Amendments to the Drawings:

FIG. 1

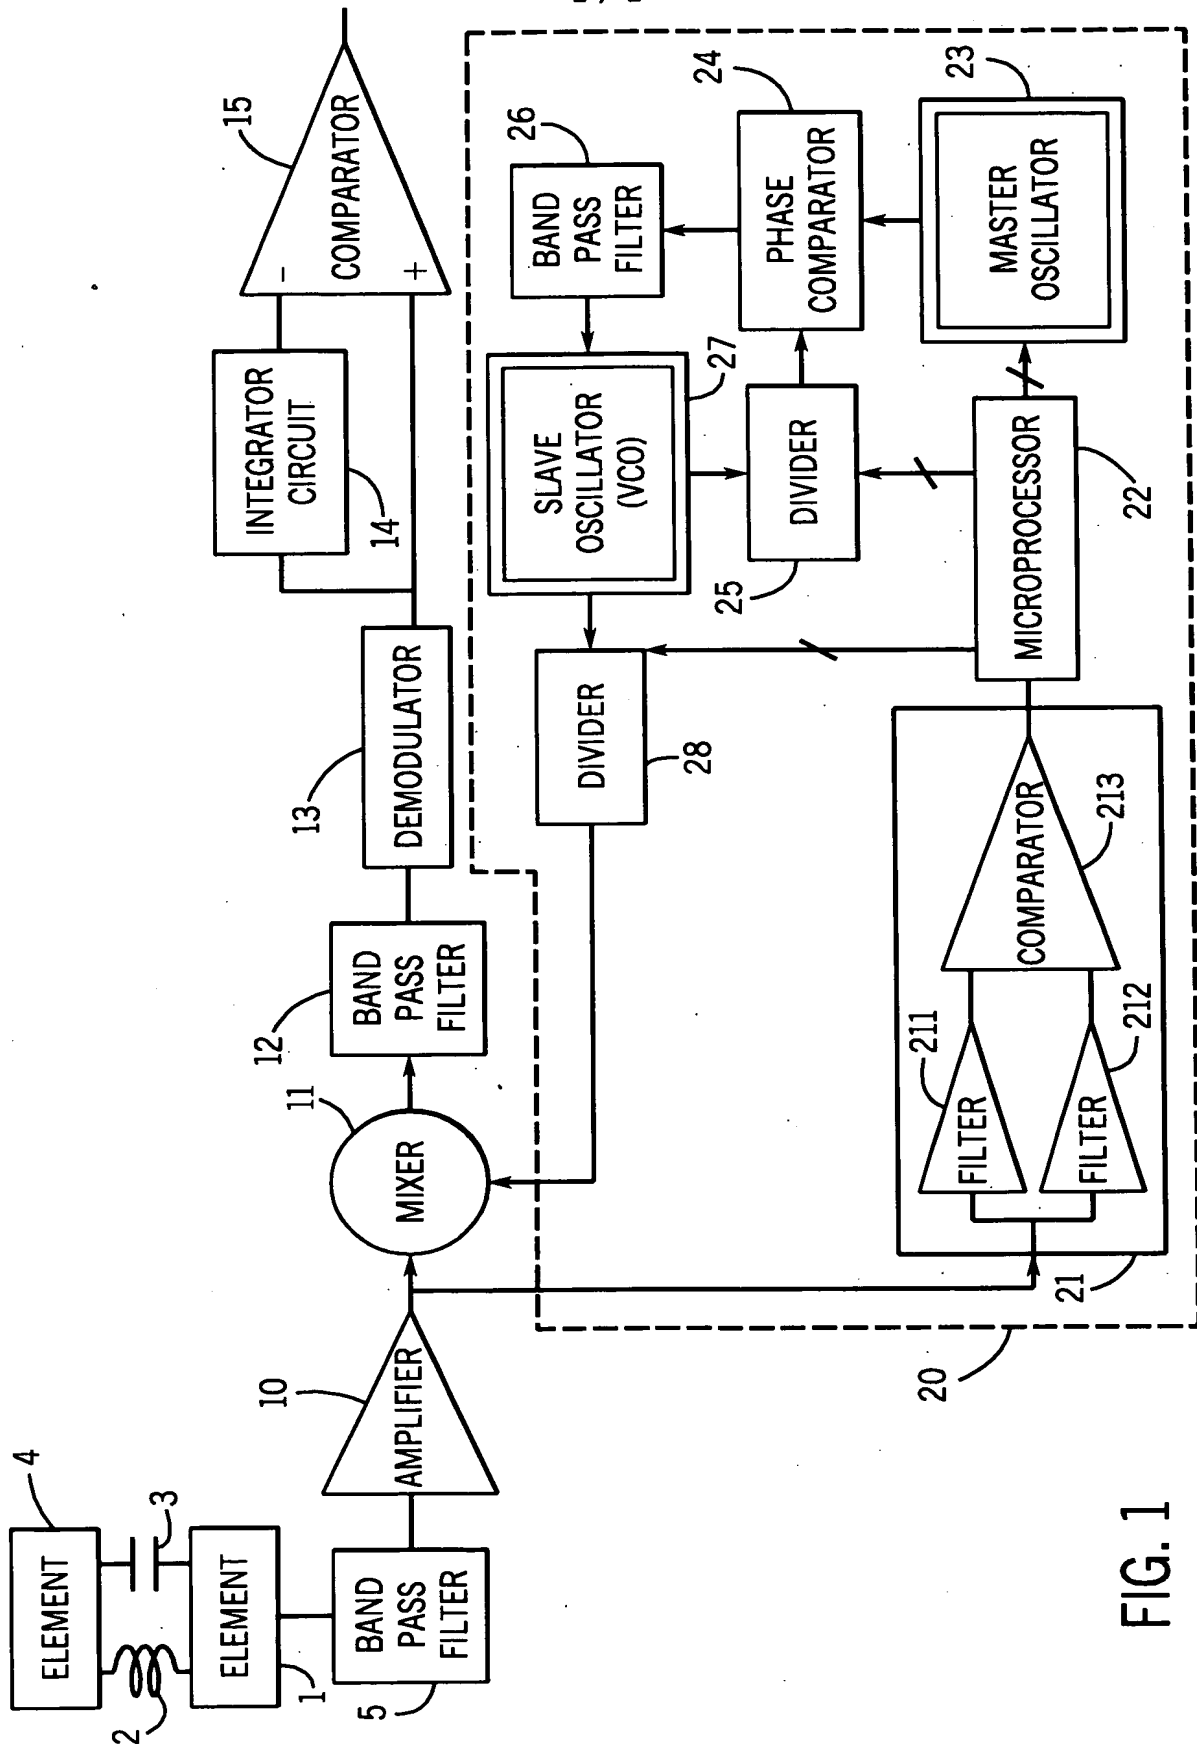
The specific changes which have been made to Figure 1 are the addition of descriptive labels to elements, in particular: block 1 has been labeled ELEMENT, block 4 has been labeled ELEMENT, block 5 has been labeled BAND PASS FILTER, block 10 has been labeled AMPLIFIER, block 11 has been labeled MIXER, block 12 has been labeled BAND PASS FILTER, block 13 has been labeled DEMODULATOR, block 14 has been labeled INTEGRATOR CIRCUIT, block 15 has been labeled COMPARATOR, block 211 has been labeled FILTER, block 212 has been labeled FILTER, block 213 has been labeled COMPARATOR, block 22 has been labeled MICROPROCESSOR, block 23 has been labeled MASTER OSCILLATOR, block 24 has been labeled PHASE COMPARATOR, block 25 has been labeled DIVIDER, block 26 has been labeled BAND PASS FILTER, block 27 has been labeled SLAVE OSCILLATOR (VCO) and block 28 has been labeled DIVIDER.
